Accessibility Survey

City of Downey

Benares Street - Norlain Avenue To Julius Avenue

Date of Inspection
2/14/2017

Sidewalks : 60X60 Turn Area

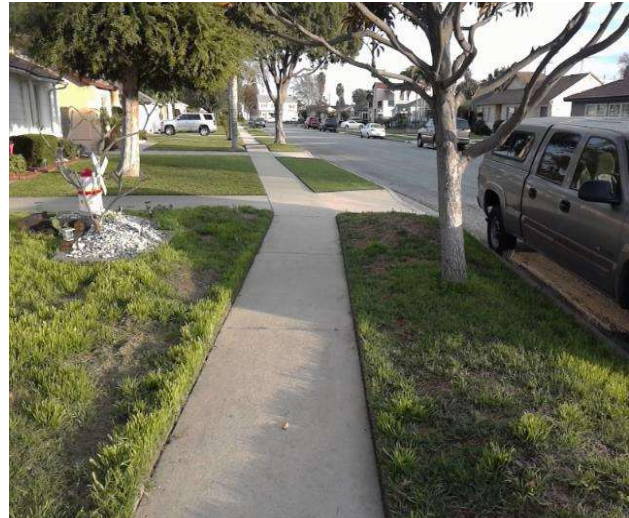
There is no 60X60 turn area at every 200 feet.

On-Site Finding Not Found

Provide a 60X60 turn every 200 feet on the sidewalk.

Bush East Of Mitla Avenue @ 33.946194719673, -118.157815486193

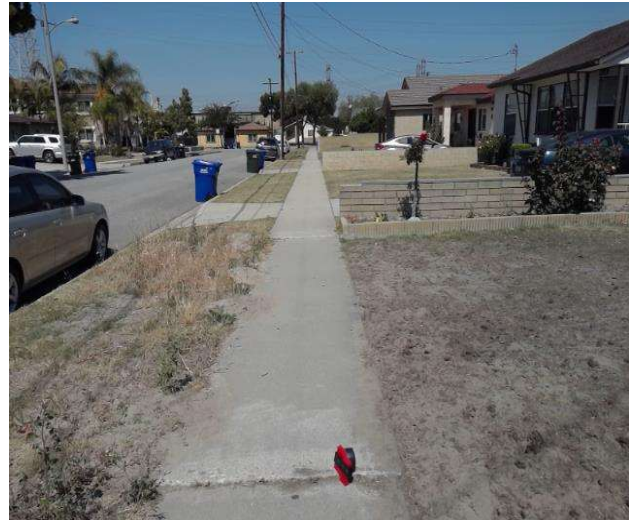
There is a change in elevation greater than recommended value.

On-Site Finding 0.75 inches

Ensure that the change in elevation is within the recommended value.

Recommendation Up to 0.25 inches

Change In Level East Of Mitla Avenue @ 33.945765282093, -118.157020211220

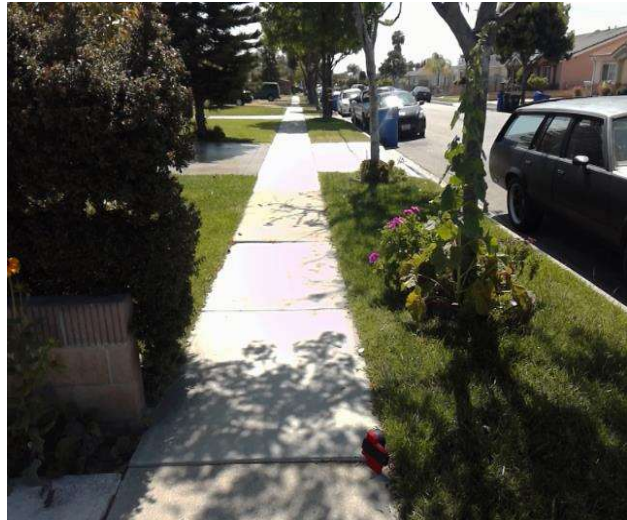
There is a change in elevation greater than recommended value.

On-Site Finding 1.00 inches

Ensure that the change in elevation is within the recommended value.

Recommendation Up to 0.25 inches

Change In Level West Of Old River School Road @ 33.943705954161, - 118.153764009476

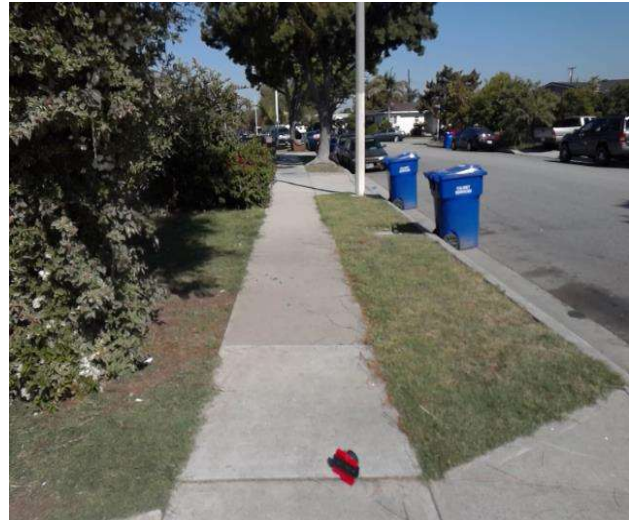
There is a change in elevation greater than recommended value.

On-Site Finding 0.62 inches

Ensure that the change in elevation is within the recommended value.

Recommendation Up to 0.25 inches

Change In Level West Of Old River School Road @ 33.943869500664, - 118.153957128525

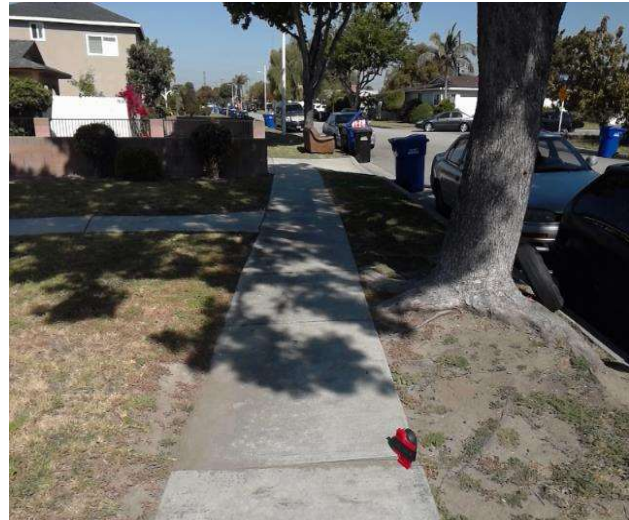
There is a change in elevation greater than recommended value.

On-Site Finding 1.25 inches

Ensure that the change in elevation is within the recommended value.

Recommendation Up to 0.25 inches

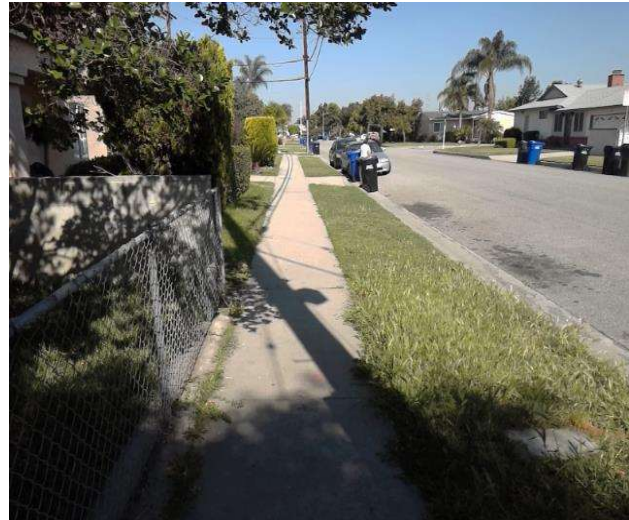
Sidewalk cross slope is not compliant.

On-Site Finding 3.70 percent for 146.00 feet

Repave the sidewalk surface with the recommended cross slope.

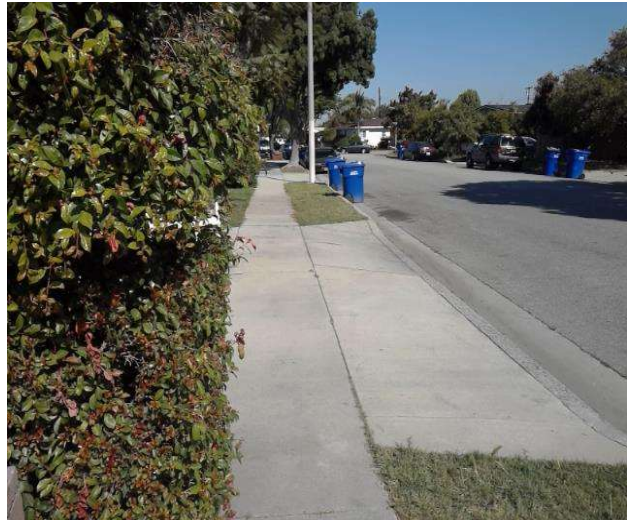
Sidewalk cross slope is not compliant.

On-Site Finding 3.40 percent for 101.00 feet

Repave the sidewalk surface with the recommended cross slope.

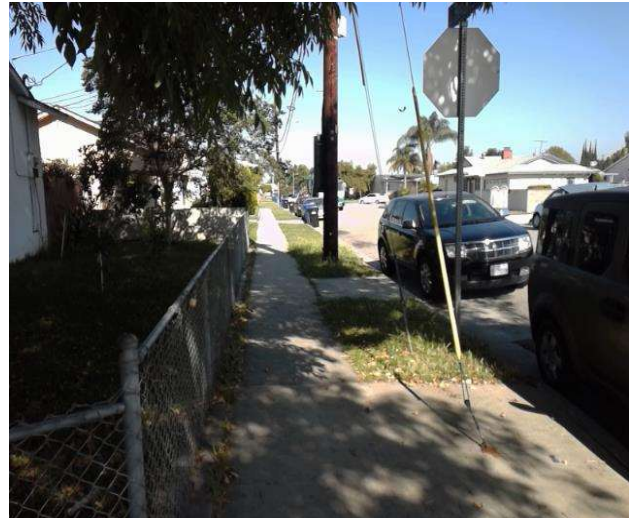
Turn area is not level.

On-Site Finding Not Level

Make sure that the turn area is level.

Change In Level East Of Rives Avenue @ 33.938466737012, -118.145710676908

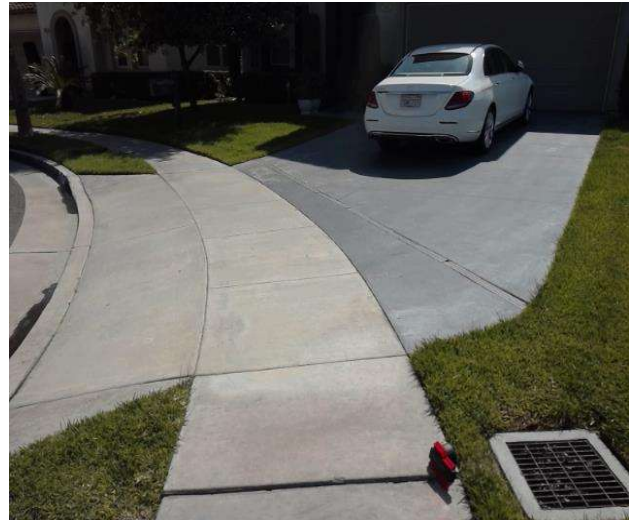
There is a change in elevation greater than recommended value.

On-Site Finding 0.75 inches

Ensure that the change in elevation is within the recommended value.

Change In Level East Of Rives Avenue @ 33.938531269573, -118.145581930876

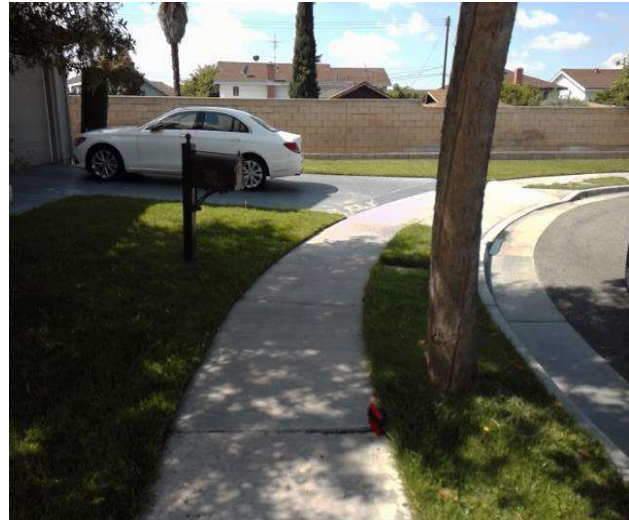
There is a change in elevation greater than recommended value.

On-Site Finding 0.50 inches

Ensure that the change in elevation is within the recommended value.

Change In Level East Of Rives Avenue @ 33.939203295405, -118.145374059677

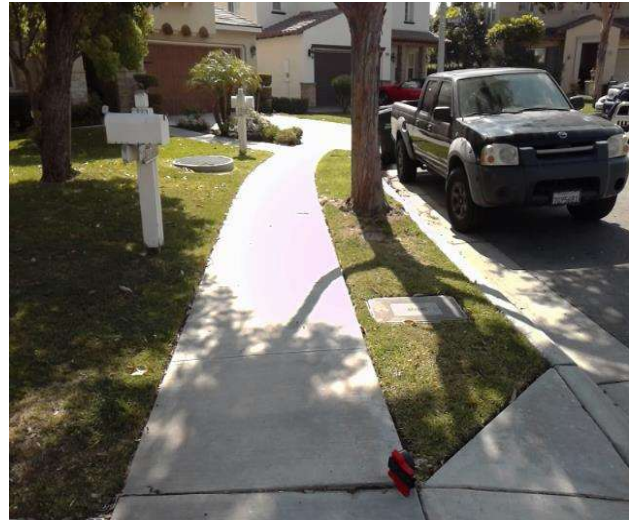
There is a change in elevation greater than recommended value.

On-Site Finding 0.75 inches

Ensure that the change in elevation is within the recommended value.

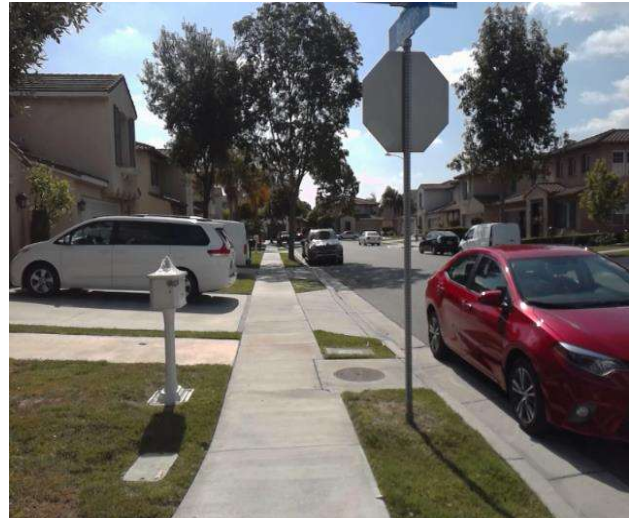
There is no 60X60 turn area at every 200 feet.

On-Site Finding Not Found

Provide a 60X60 turn every 200 feet on the sidewalk.
